Task Force 2 – Receptacles
Proposal after Stuttgart IWG Meeting

Recommendation for Part I: Statement of technical rationale and justification

5.2.1.1 Fuelling receptacle requirements

Figure 1 — H35 Hydrogen receptacle

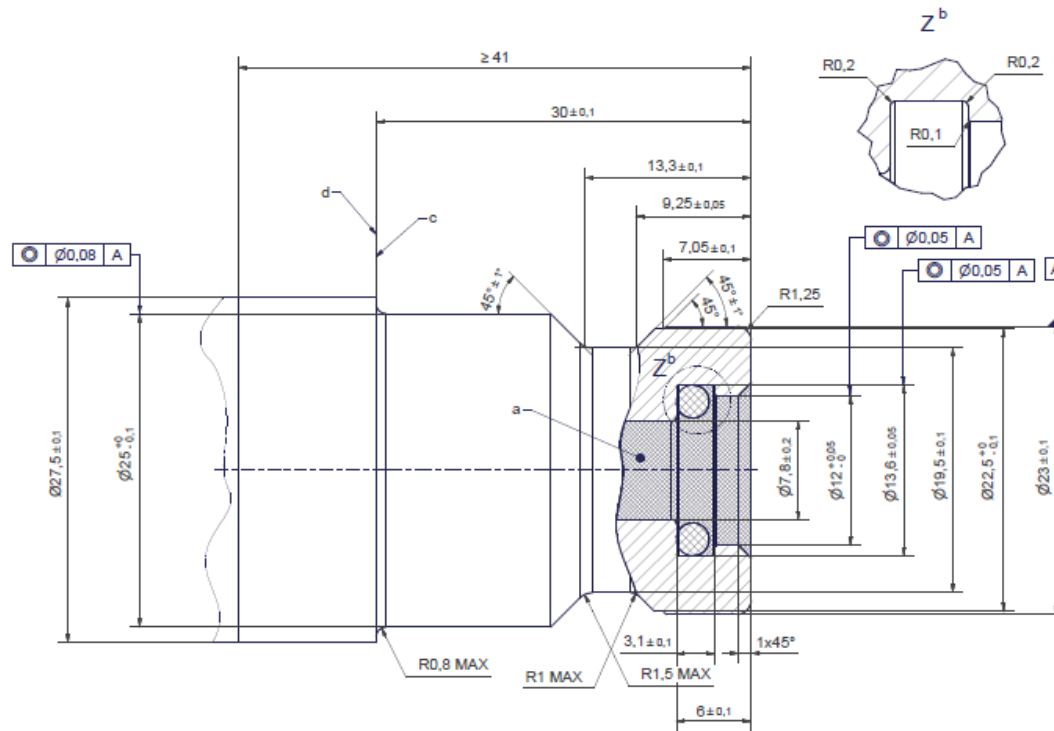
5.2.1.1.1 The fuelling receptacle shall prevent reverse flow to the atmosphere. Test procedure is by visual inspection. The geometry of the fuelling receptacle shall be designed as specified in figures 1-4. Figure 5 is presented as an example countermeasure against nozzle-receptacle freezing issues.

Figure 5 — Example hex design (Proposal 1)

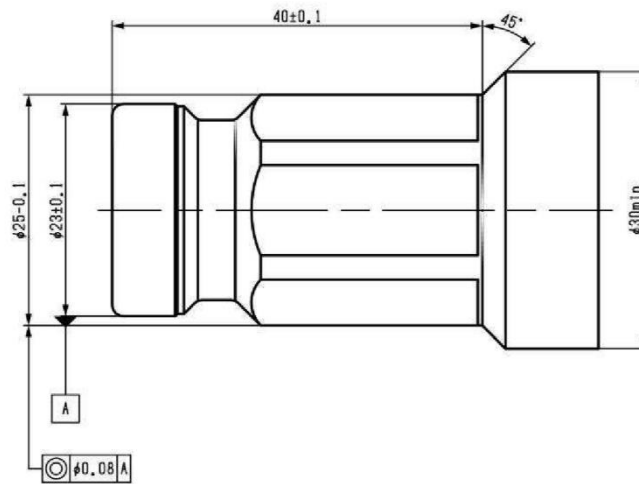
5.2.1.1.1 The fuelling receptacle shall prevent reverse flow to the atmosphere. Test procedure is by visual inspection. The geometry of the fuelling receptacle shall be designed as specified in ISO 17268:2019 and SAE J2600 (2019), or subsequent revisions, and identified therein as H35, H35HF, H70 and H70HF. Figure 1 is presented as an example countermeasure against nozzle-receptacle freezing issues.

Note: This design is an example countermeasure against freezing issues.
